# SCHWEIZER SERVICE NOTICE

**SUBJECT:** INSTRUMENT CLUSTER 3-PACK CONVERSION - AC TO ROCHESTER  
(28 VOLT)

**MODELS AFFECTED:** Model 269A (TH-55A) Helicopter Serial No. 0315 through 1110  
Model 269A-1 Helicopter Serial No. 0019 through 0041  
Model 269B Helicopter Serial No. 0001 through 0463  
Model 269C Helicopter Serial No. 0001 through 0949

Figure 1. Modification of Instrument Panel (Model 269B and 269C)

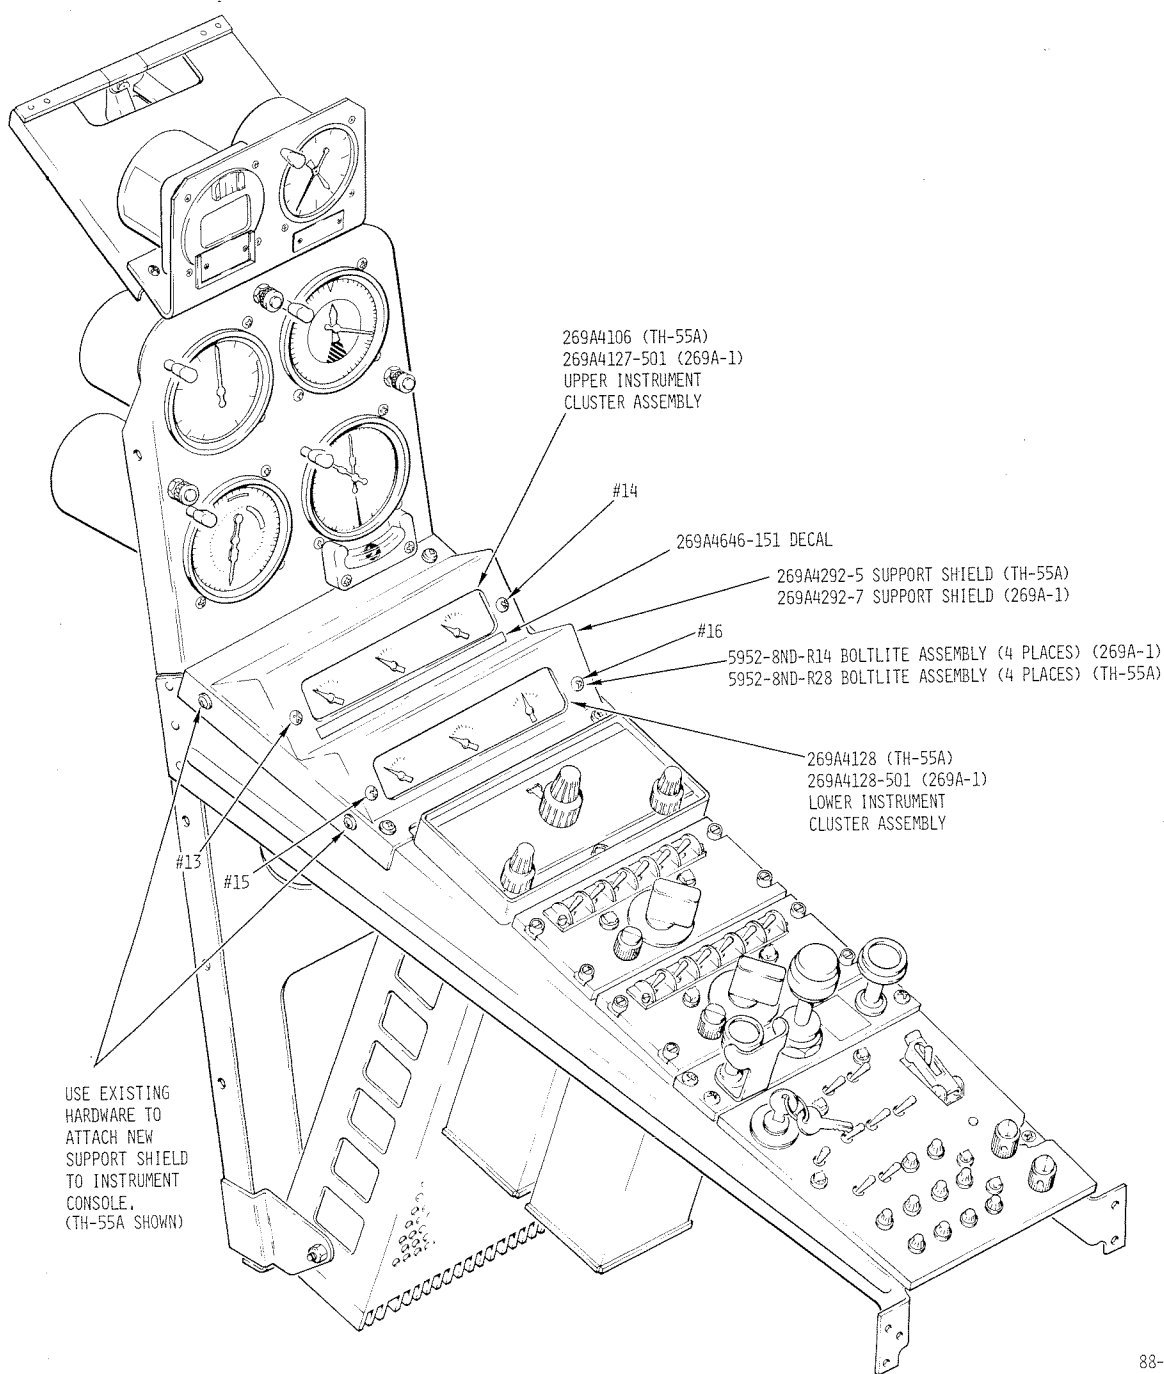
2. Modify instrument panel openings as shown in Figure 1. Use metal cutting saw.
3. Locate doubler on instrument panel. (See Figure 1.)
4. Drill fifteen 0.135/0.128 inch diameter holes in instrument panel through pilot holes in doubler. Use No. 30 drill.

5. Attach doubler to instrument panel with 15 rivets. Install rivets double flush and with zinc chromate primer.
6. Locate and drill four 0.177/0.169 inch diameter holes in instrument panel and doubler. Use No. 17 drill. (See Figure 1.)

7. Locate and drill four 0.182/0.176 inch diameter holes in instrument panel and doubler. Use No. 15 drill. (See Figure 1.)
8. Install PN 269A4106, 269A4106-501 or 269A4127-501 instrument cluster assembly in upper opening of instrument panel; and PN 269A4107, 269A4107-501 or 269A4128-501 instrument cluster assembly in lower opening. Secure each instrument cluster assembly with two screws and two nuts.

9. Install four boltlite assemblies on instrument panel. (See Figure 1.)

10. Install PN 269A4646-227 (269C helicopter serial nos. 0210 through 0949) or PN 269A4646-229 (269C helicopter serial nos. 0001 through 0209) decal on instrument panel. (See Figure 1.)
  11. Install PN 269A4646-231 decal on instrument panel (269B helicopters only).
  12. Fill existing holes in instrument panel with Kwik Kure No. 248 or Akemi No. 7 per manufacturer's instructions and touch up per Basic HMI.
- d. Install instrument cluster assemblies on console as follows:  
(Model 269A-1 and TH-55A only) (See Figure 2.)
1. Remove and retain hardware attaching support shield to console. Disconnect instrument cluster assembly wiring and remove support shield and instrument cluster assemblies.

- i. Reinstall fairing assembly on instrument panel. (Refer to Section 14 of Basic HMI.)
- j. Install PN 269A4646-175 decal on instrument panel as shown in Figure 1.

1. MODIFY EXISTING PANEL OPENINGS TO DIMENSIONS INDICATED, LOCATE AS SHOWN.
2. FILL EXISTING HOLES WITH KWIK KURE NO. 248 OR AKEMI NO. 7 AND TOUCHUP PAINT TO MATCH PANEL.
3. USED ON MODEL 269C SERIAL NO. 0210 THRU 0949.
4. USED ON MODEL 269C SERIAL NO. 0001 THRU 0209.
5. USED ON MODEL 269B ALL SN.

Figure 2. Installation of Instrument Cluster Assemblies  
(Model 269A-1 and TH-55A)

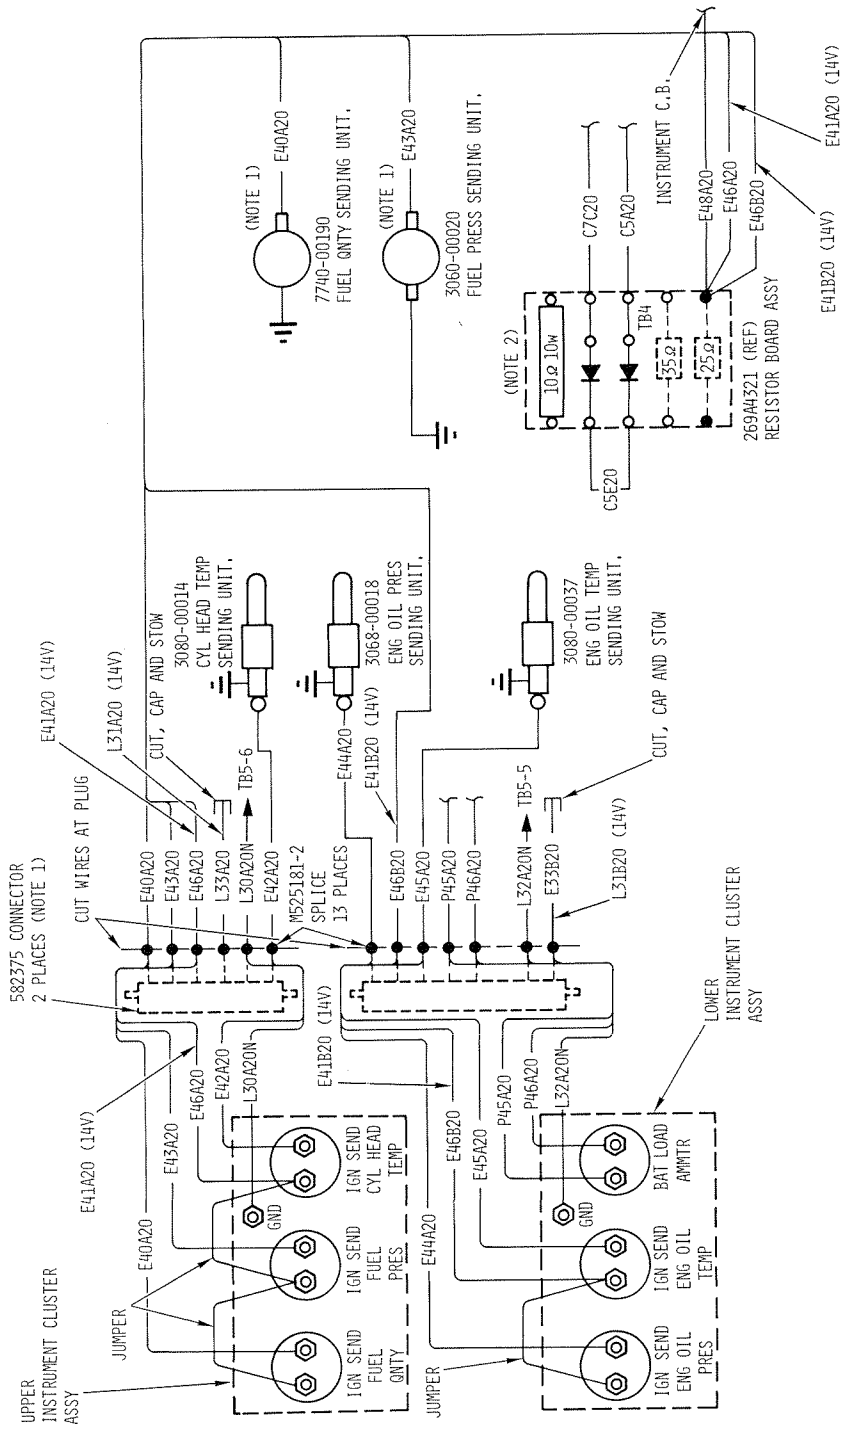
2. Install PN 269A4106 (TH-55A) or 269A4127-501 (269A-1) instrument cluster assembly in upper opening and PN 269A4128 (TH-55A) or 269A4128-501 (269A-1) instrument cluster assembly in lower opening of new support shield. Secure each instrument cluster assembly to support shield with two boltlite assemblies.

3. Install new 269A4292-5 (TH-55A) or 269A4292-7 (269A-1) support shield, and instrument cluster assemblies on console with hardware retained in Step 1 above.

4. Install PN 269A4646-151 decal as shown.
- e. Replace senders as follows:
1. Remove existing fuel quantity sender and install new fuel quantity sender. (Refer to Section 5 of Basic HMI.)

Figure 3. Wiring Diagram

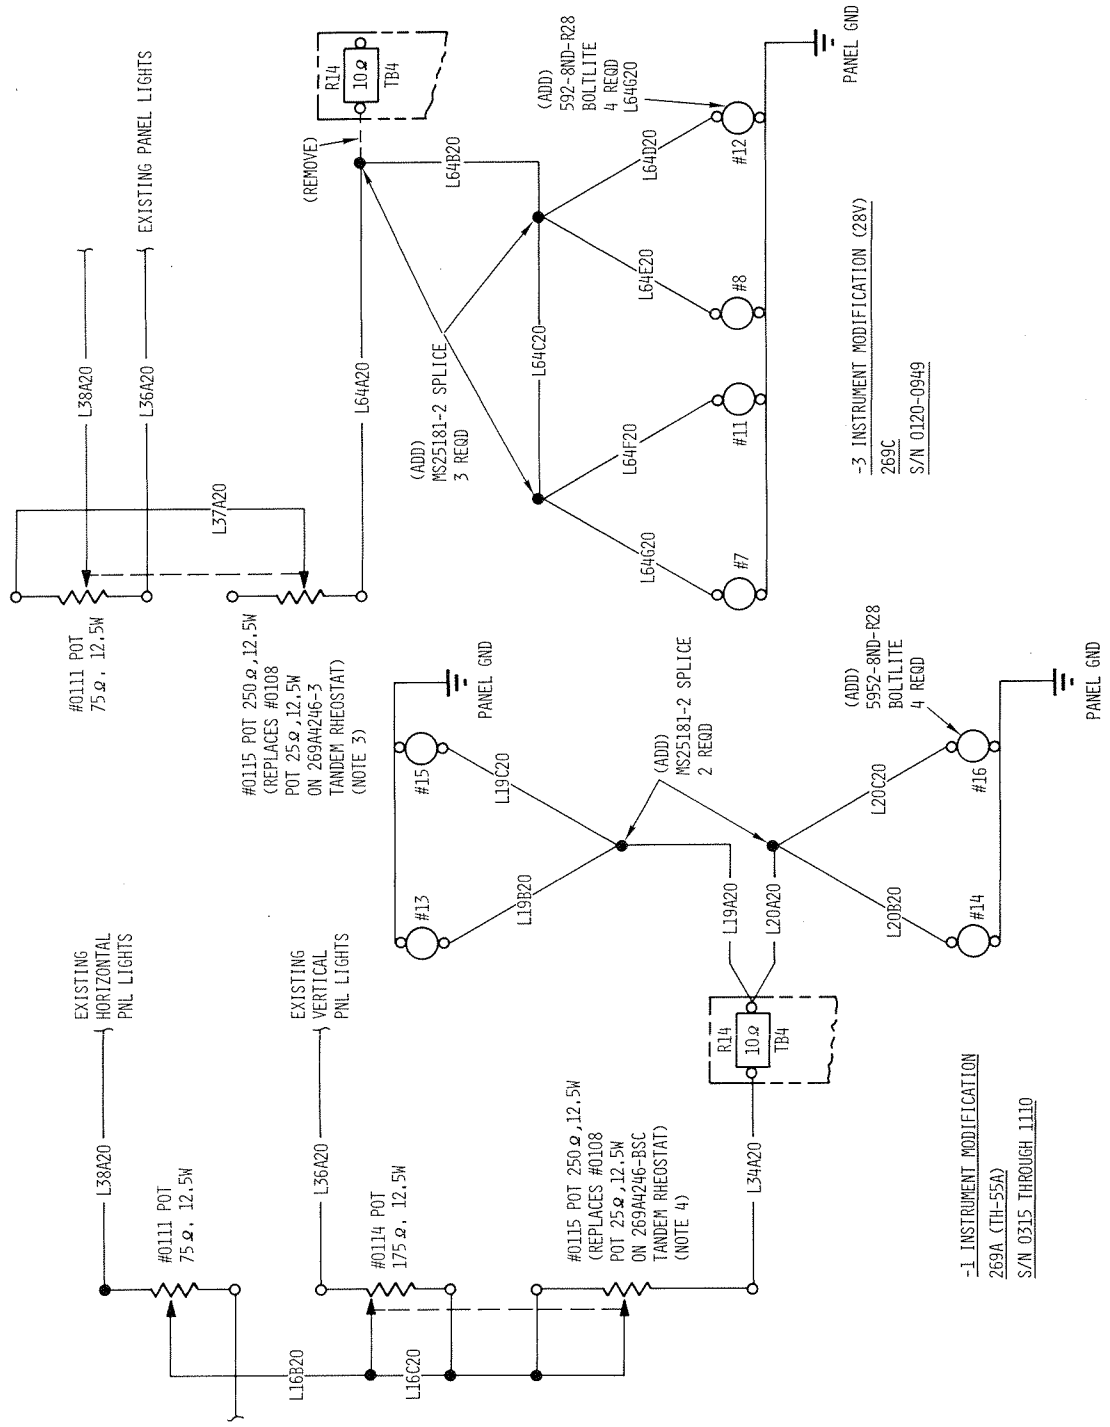
- f. Rework electrical system components and wiring as shown in Figure 3.
- g. Check all wiring for proper routing, termination and security.
- h. Turn on electrical power and check all instruments for proper operation.

- NOTES**
1. REMOVE 582375 CONNECTORS FROM EXISTING WIRES AND REPLACE WITH APPROPRIATE AMP INC. TERMINAL
  2. REMOVE 25 OHM RESISTERS FROM TERMINAL BOARD ASSY. WIRE NOS. E48A20 E46A20 AND E46B20 MAY BE SPLICED TOGETHER OR TERMINATED AT A COMMON TERMINAL STUD ON TERMINAL BOARD ASSY.
  3. REIDENTIFY ALTERED TANDEM RHEOSTAT AS 269A4246-13
  4. REIDENTIFY ALTERED TANDEM RHEOSTAT AS 269A4246-11
